6986 PanoVu Camera Firmware

Version: V5.4.5

Release Note (External) (2017-02-24)

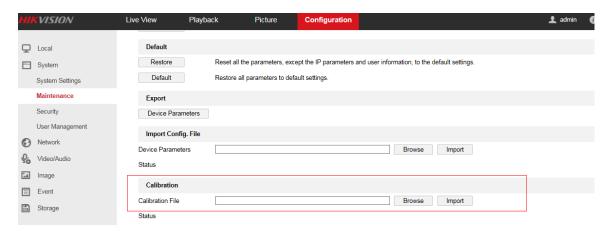
- 1. New Features
- Newly support ONVIF protocol.
- 2. Optimization
- Newly added the MJPEG format of video encoding for Sub Stream.

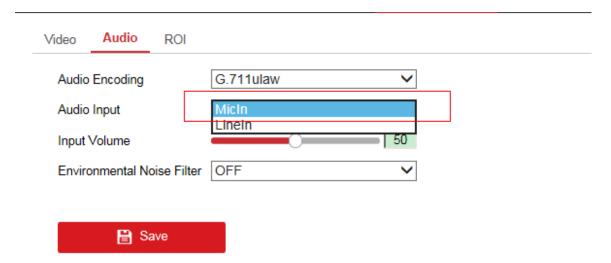
- Modify the default bitrate to 16384Kbps.
- The default resolution of main stream is 12MP (4096*1800).
- Remove the Calibration file import interface.
